Sutton Beach Pavilion, Redcliffe

Structural Condition Audit Peer Review

Moreton Bay Regional Council

Project no. 7366

1 PAVILION 1 - GROUND FLOOR (EXISTING)
103 SCALE: 1 : 150

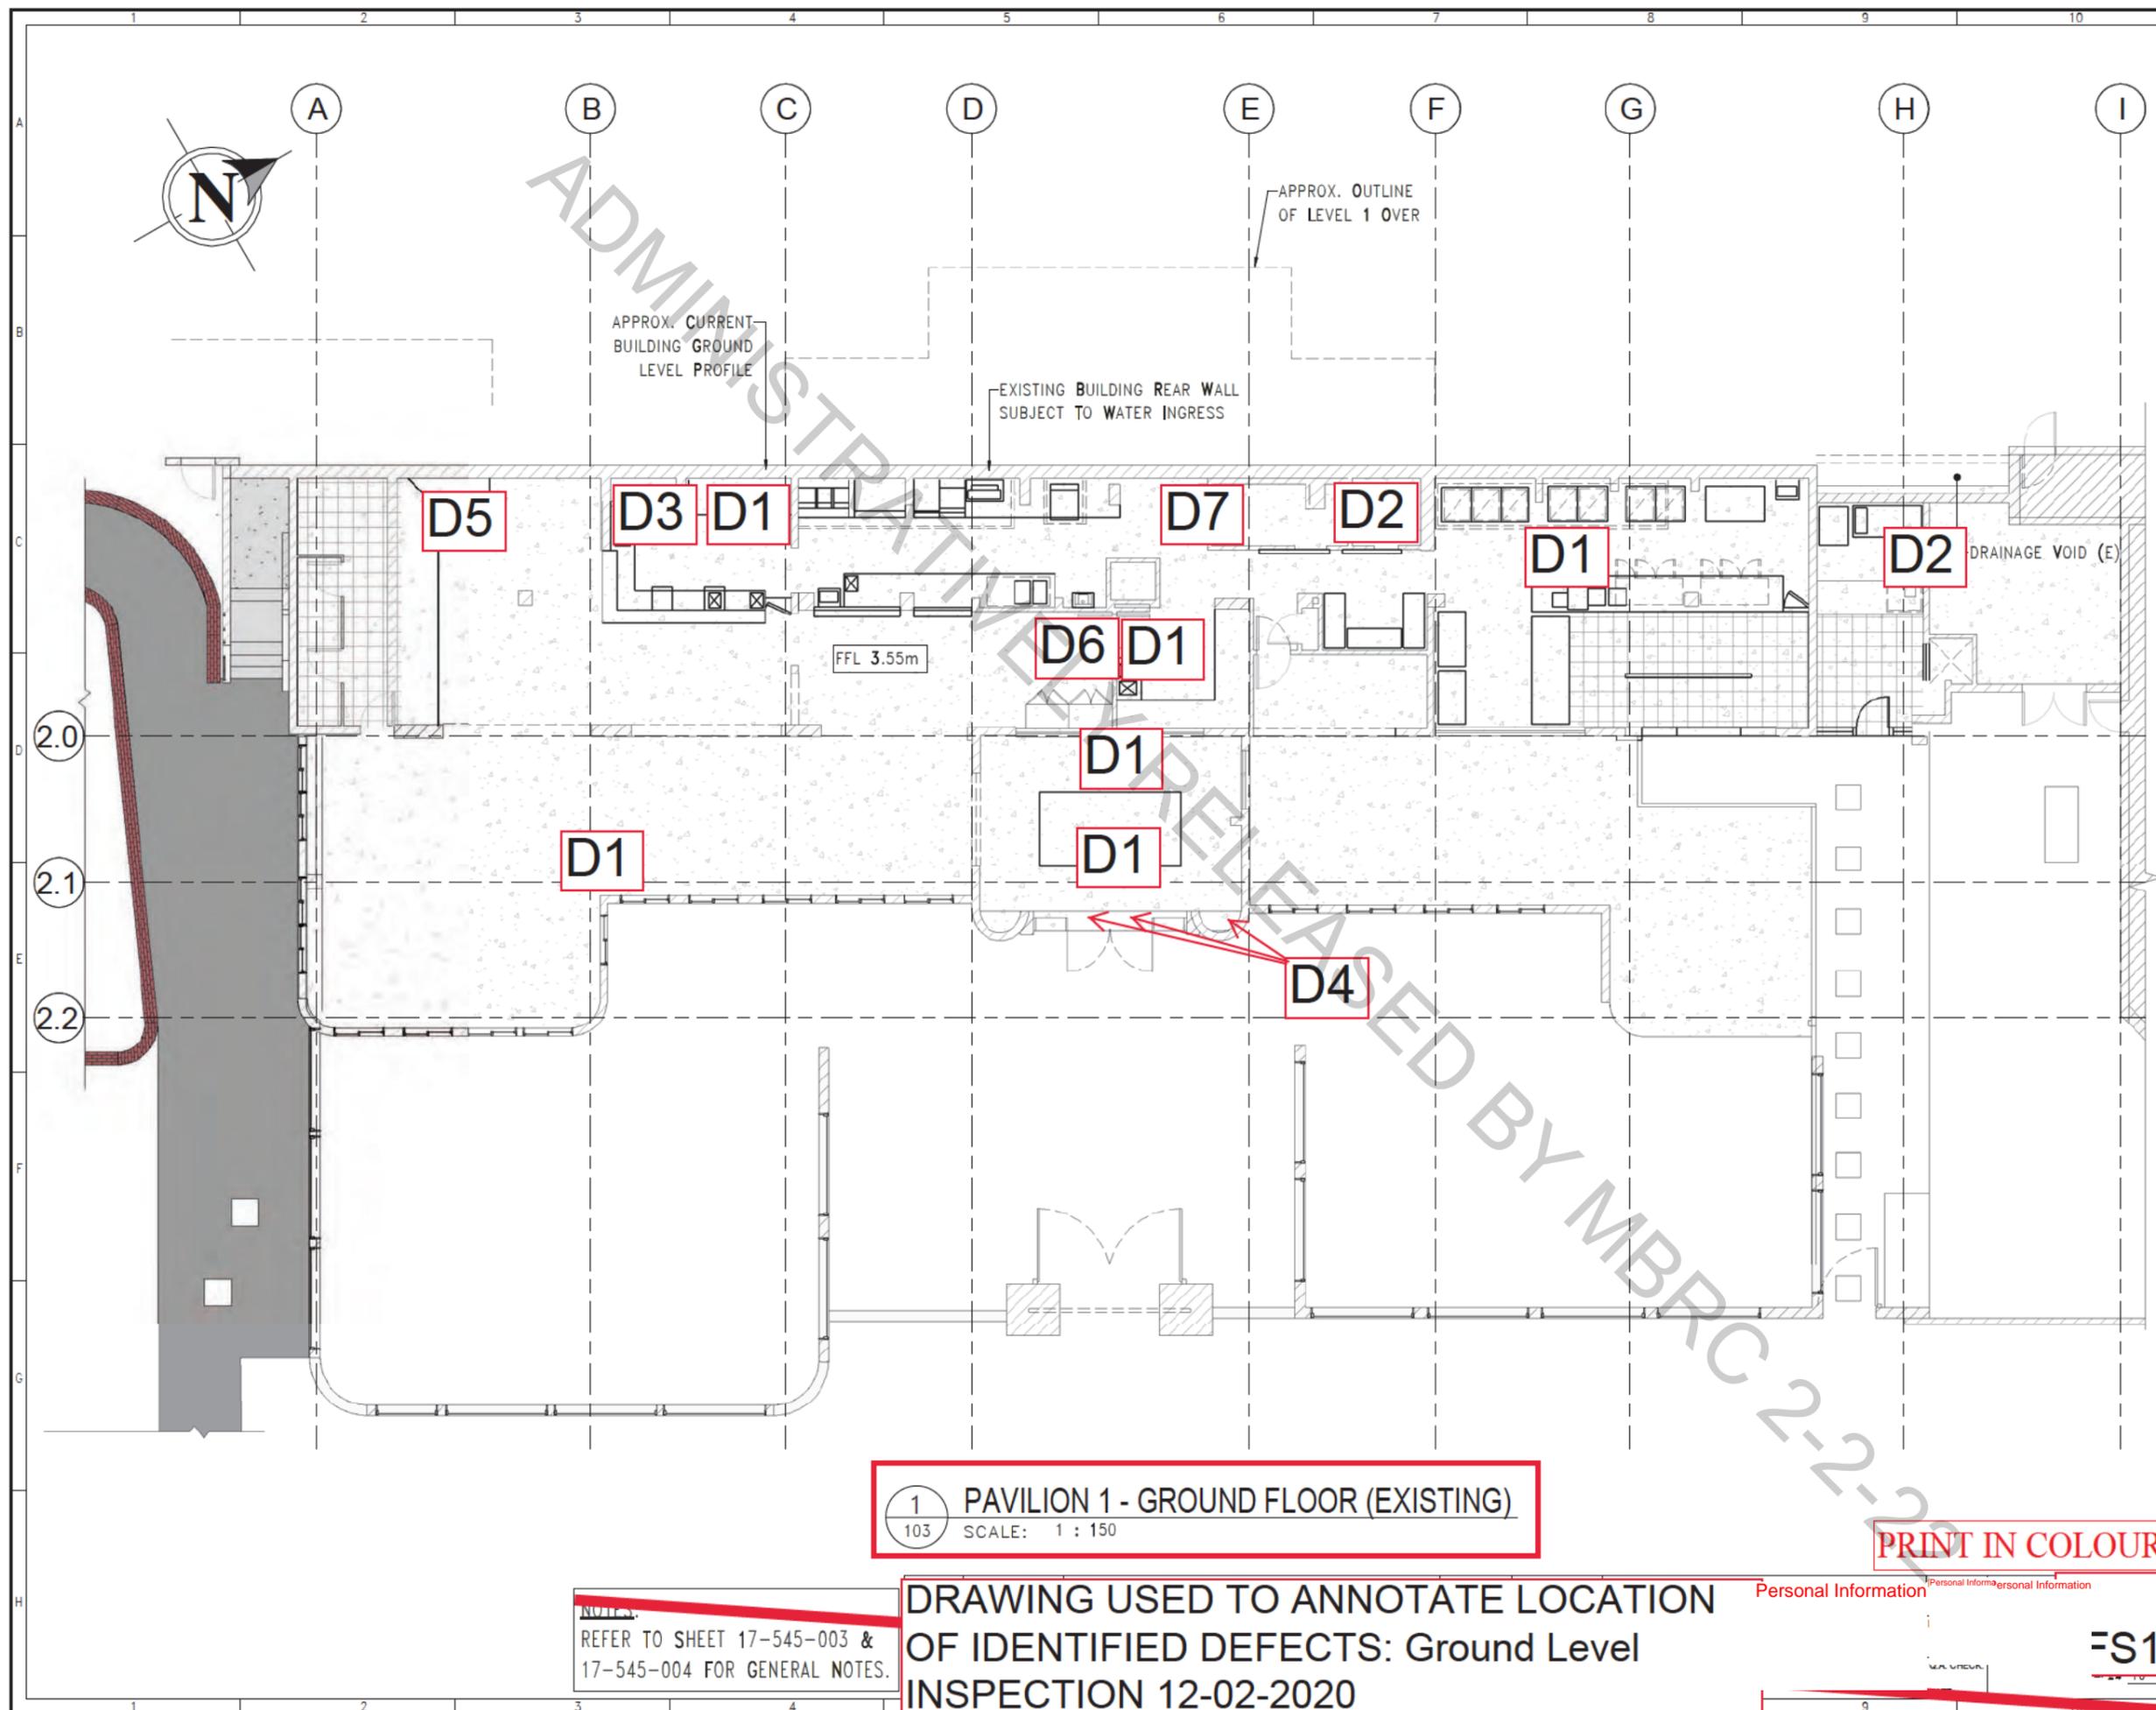
DRAWING USED TO ANNOTATE LOCATION OF IDENTIFIED DEFECTS: Ground Level INSPECTION 12-02-2020

1 PAVILION 1 - FIRST FLOOR (EXISTING)
 104 SCALE: 1 : 150

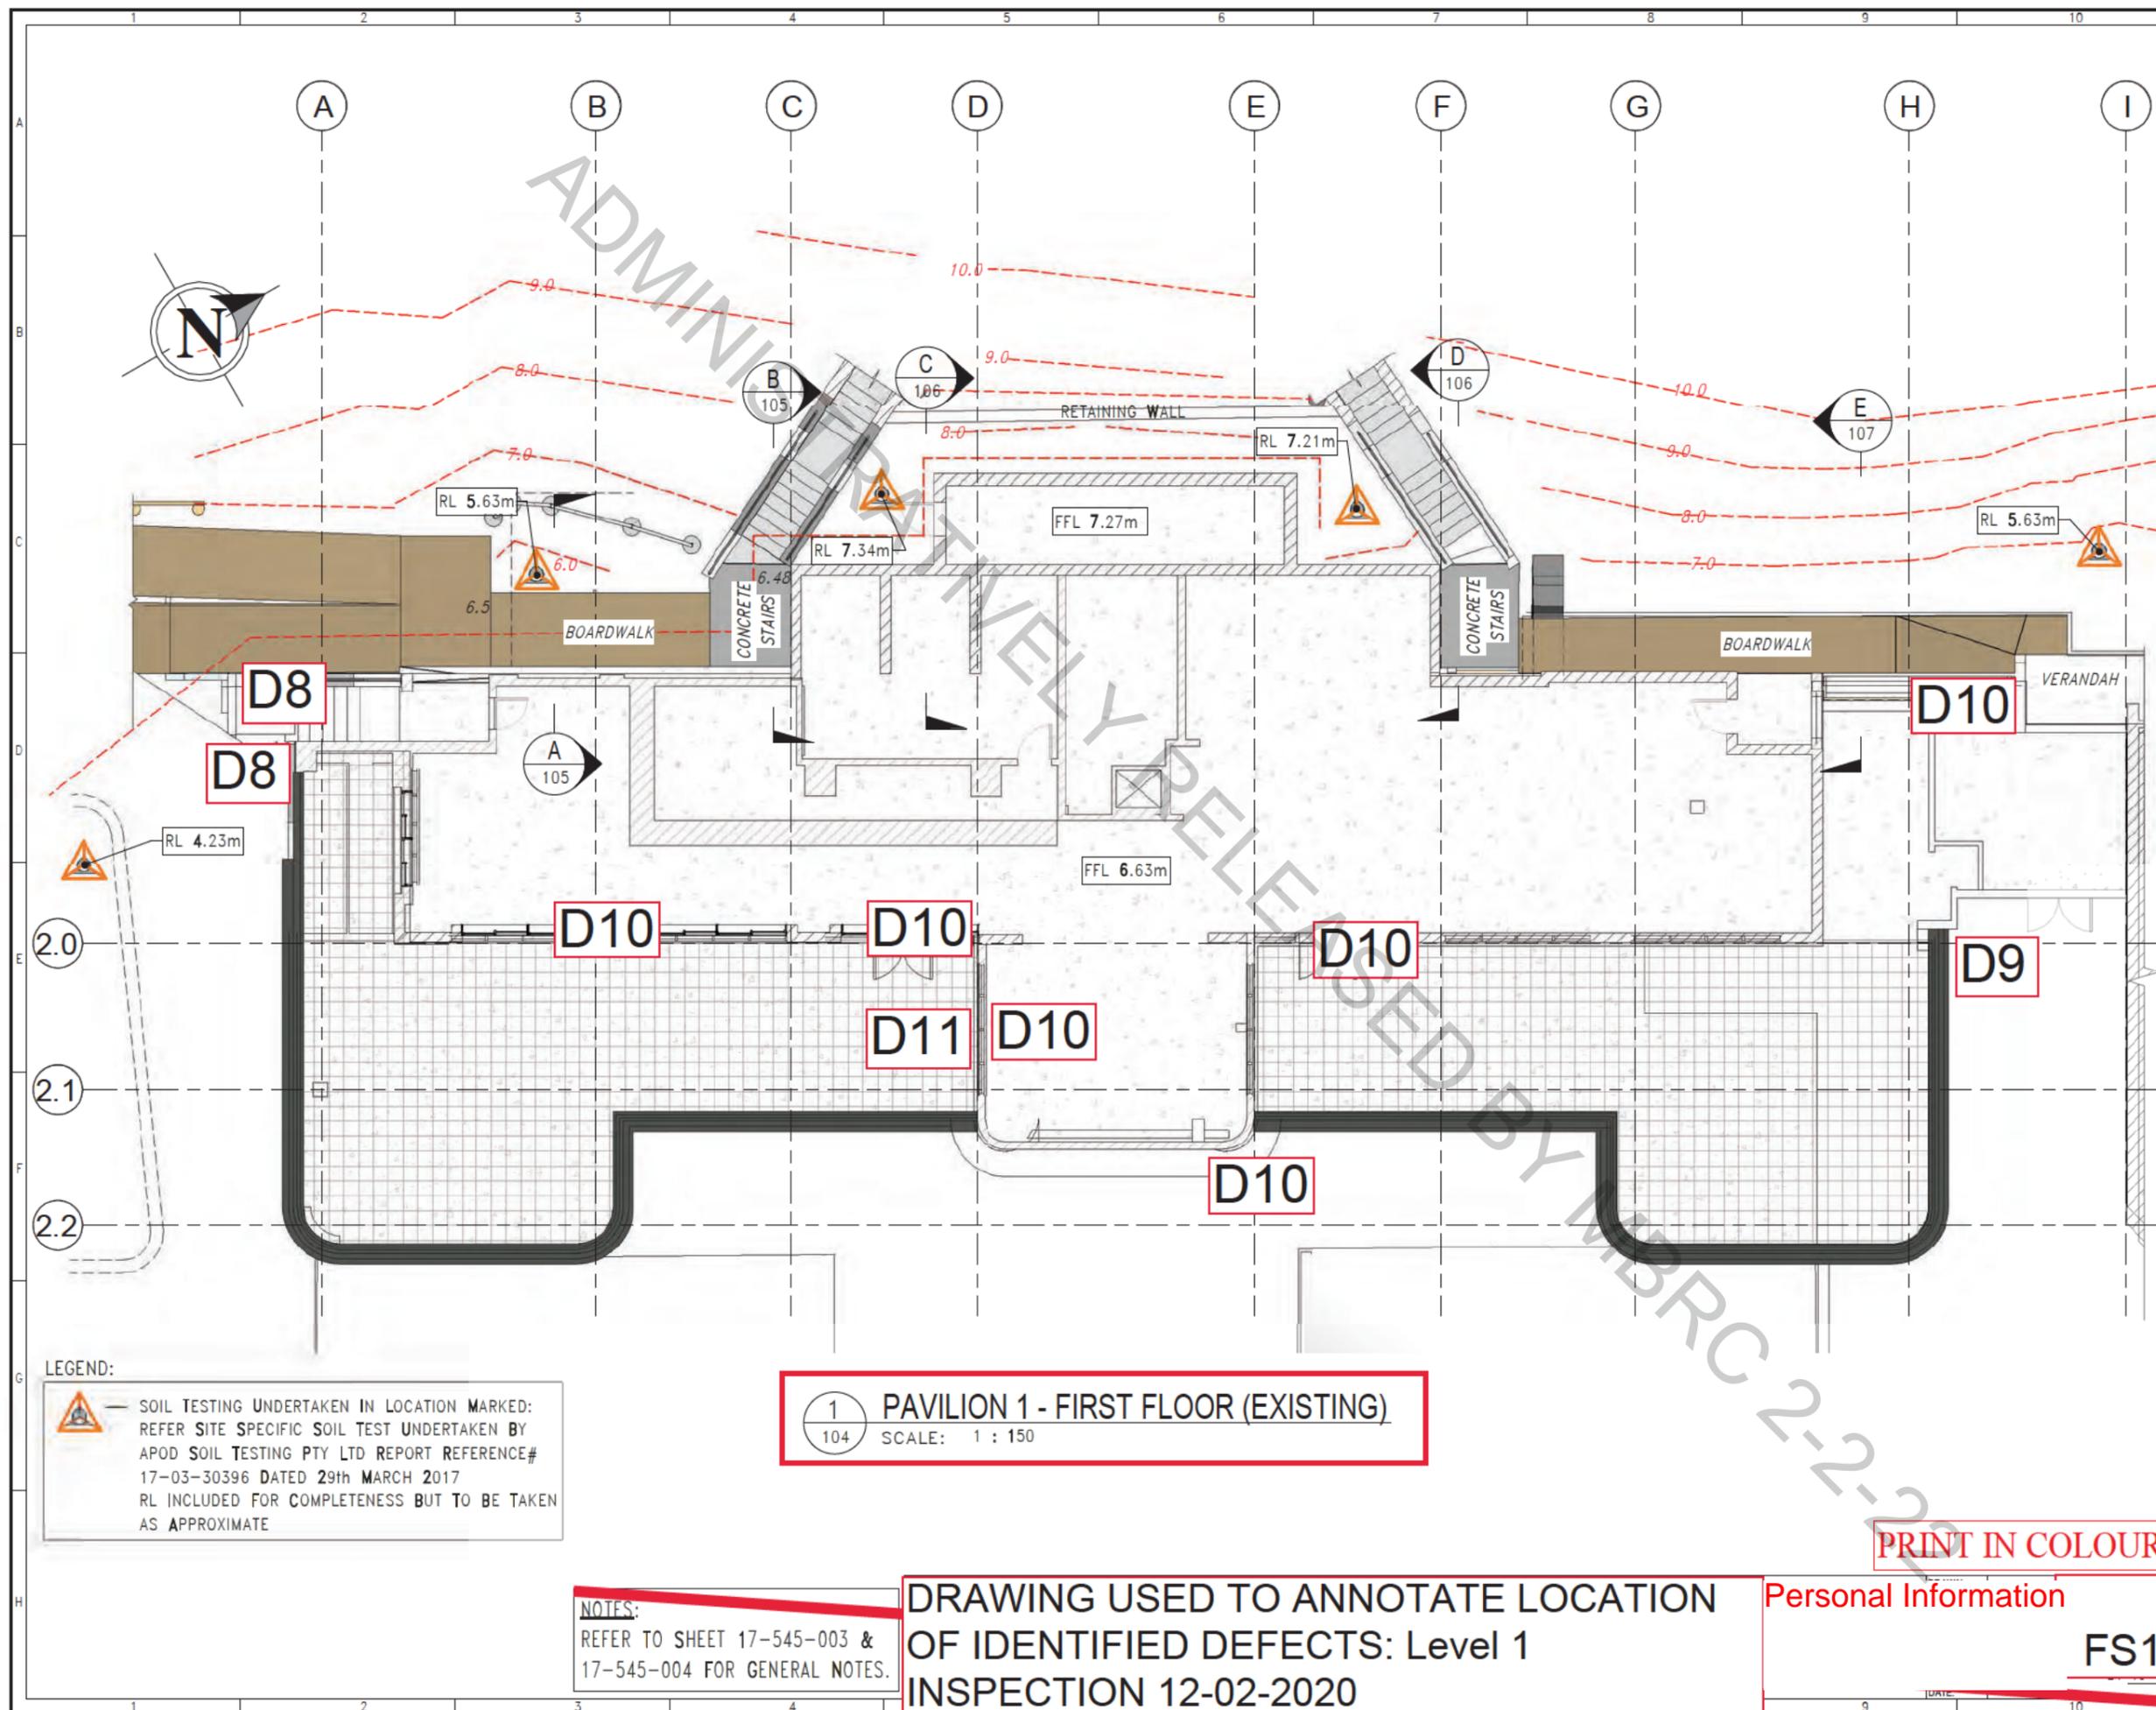
DRAWING USED TO ANNOTATE LOCATION
 OF IDENTIFIED DEFECTS: Level 1
 INSPECTION 12-02-2020

Figure 24: IMG_8538

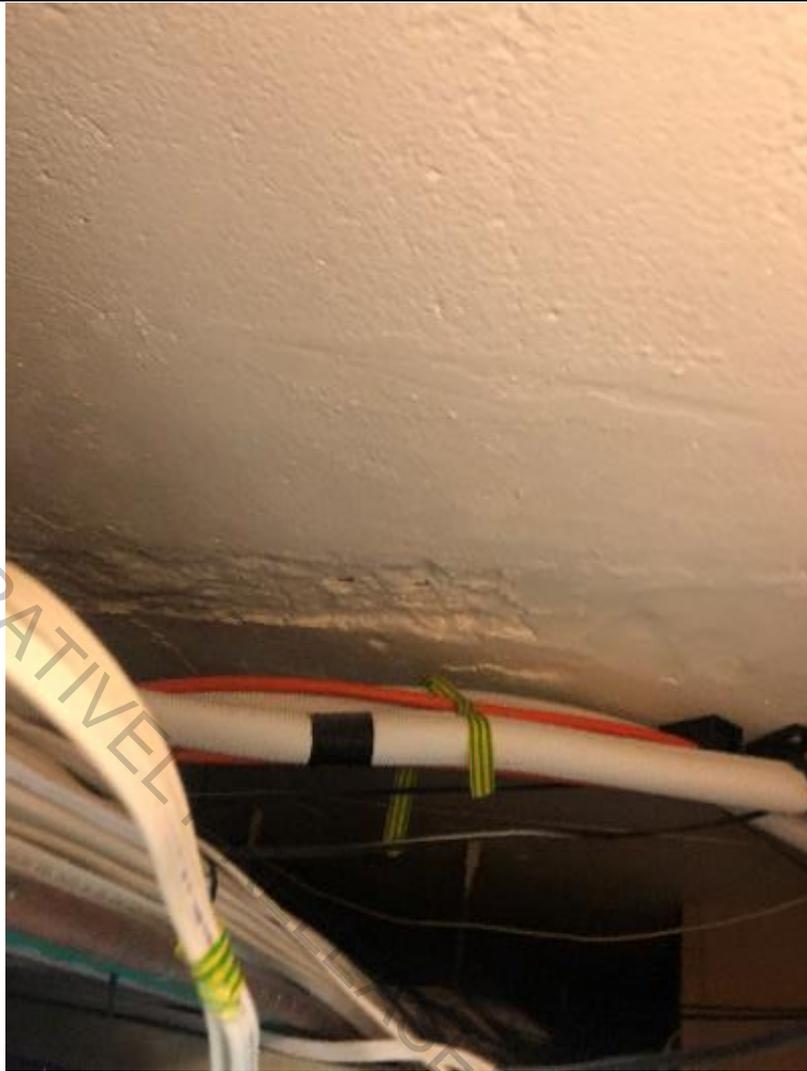
G2 – underside construction joint – past repairs

Figure 28: IMG_8526

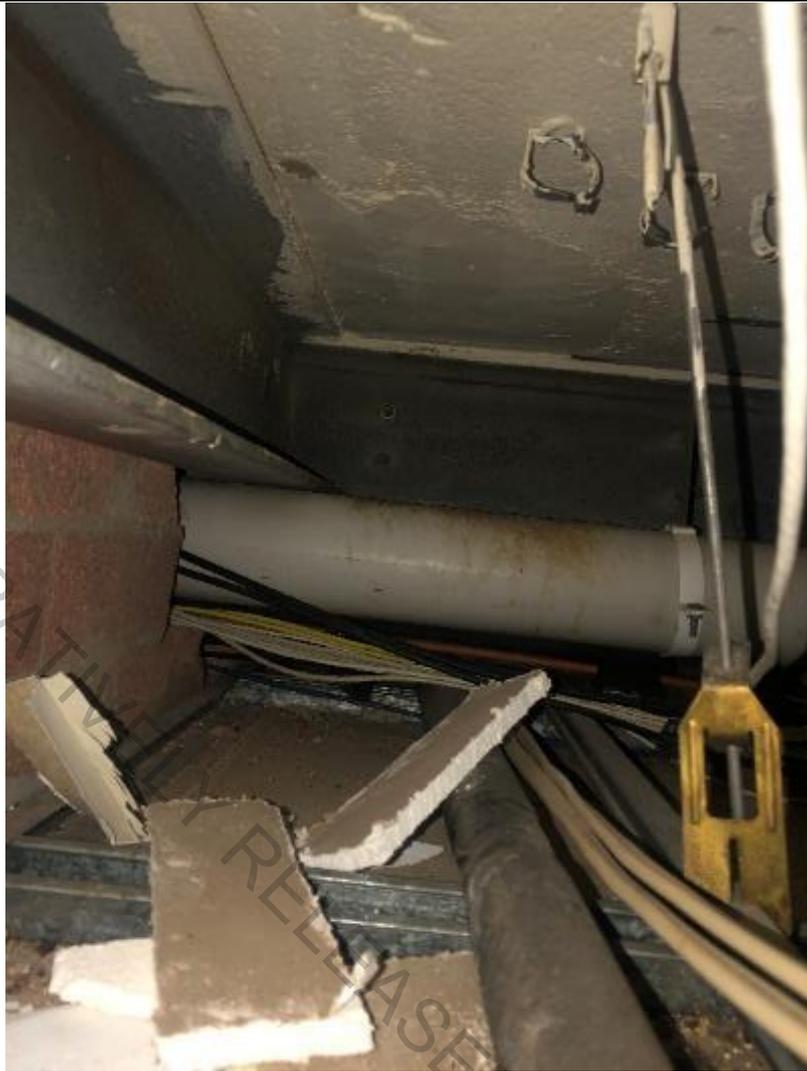
G4 – Repaired slab soffit/spalling

Figure 41: IMG_8524

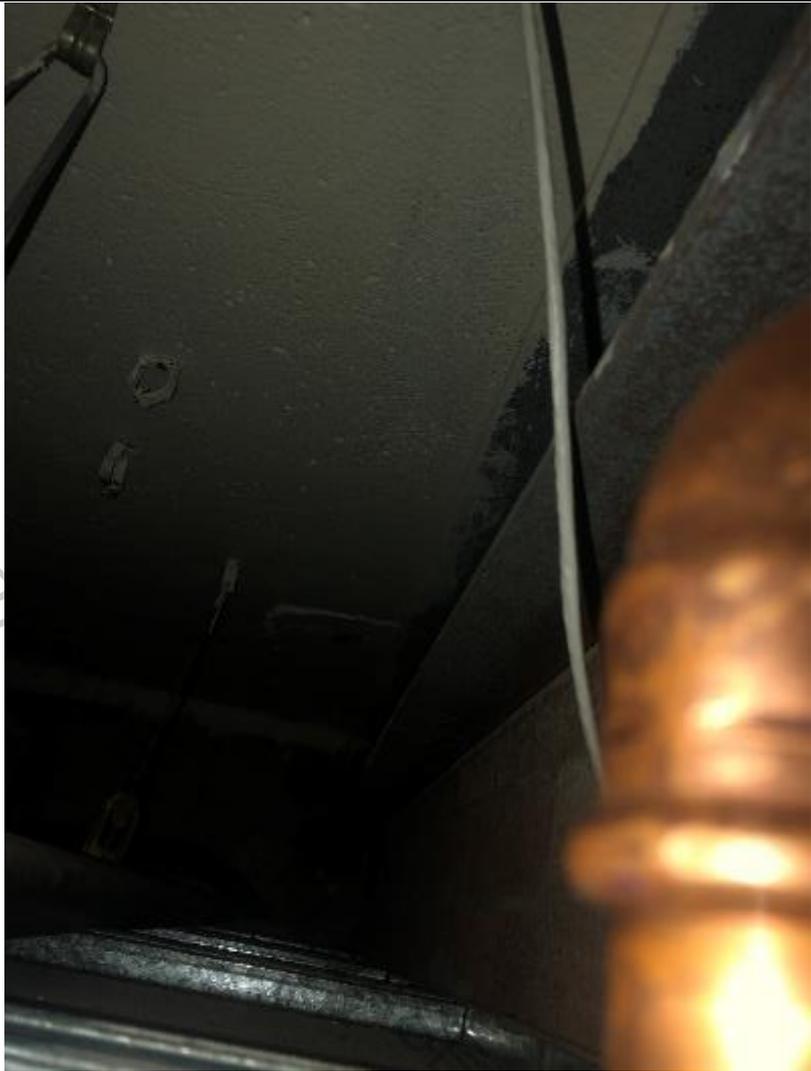
G8 – Beam Corrosion

Figure 51: IMG_8514

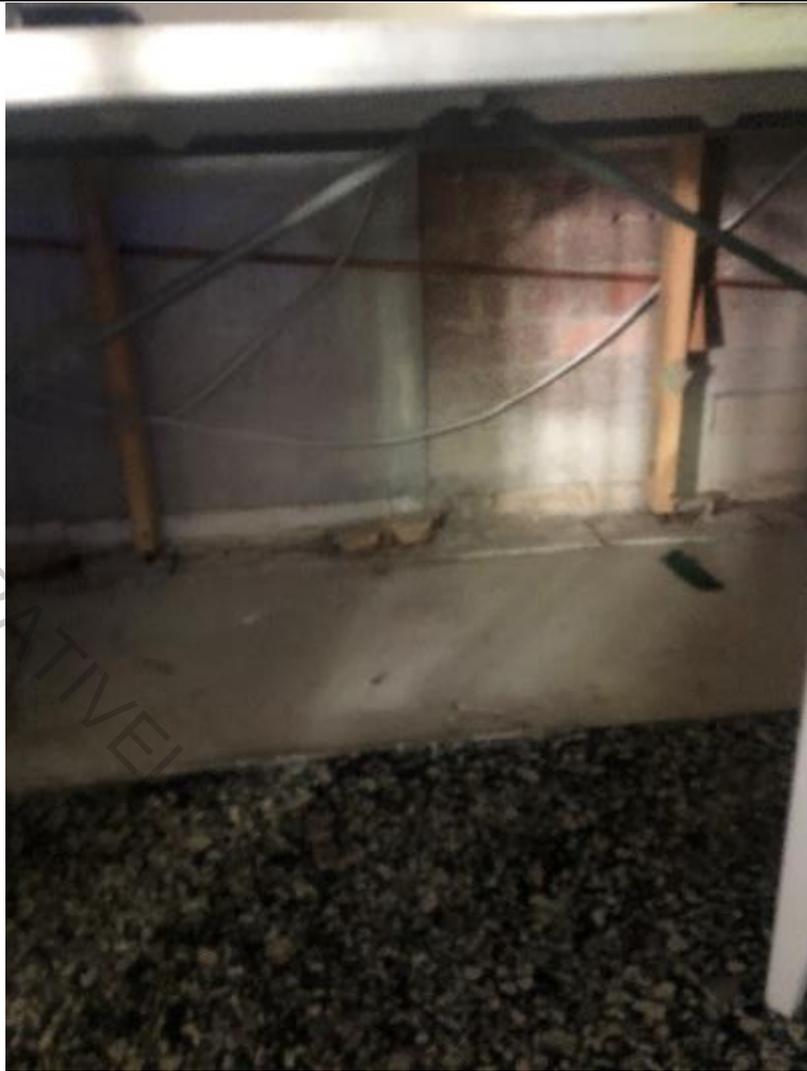
G10: Ground Floor Grid A-B	Defect D5 Water damage along full extent of western wall resulting in severe dry rot of timber. Evidence of termite damage.	Complete removal of kitchen fit out and all framing members. Resolution of water ingress through western wall is problematic.	<i>BEC sighted. In agreeance with defect & proposed repair recommendation. Additional termite inspections / monitoring recommended.</i>
G11: Ground Floor Grid D-E	Defect D6 Ceiling failure due to weight of services cables.	Removal of existing ceiling sheeting & installation of new system to support required cables.	<i>Unable to inspect. Ceiling appears to be patched in this area; repairs may have already been conducted.</i>
G12: Ground Floor Grid D-E	Defect D7 Noted condensation on existing refrigeration lines that is likely resulting in water ingress to structural members and finishes.	Removal of existing ceiling to enable make-good works to refrigeration lines.	<i>Note - Incorrect photo provided by FSACE. Sited refrigerant lines resulting in water ingress. (refer IMG_8523)</i>

G10 – Wall water damage
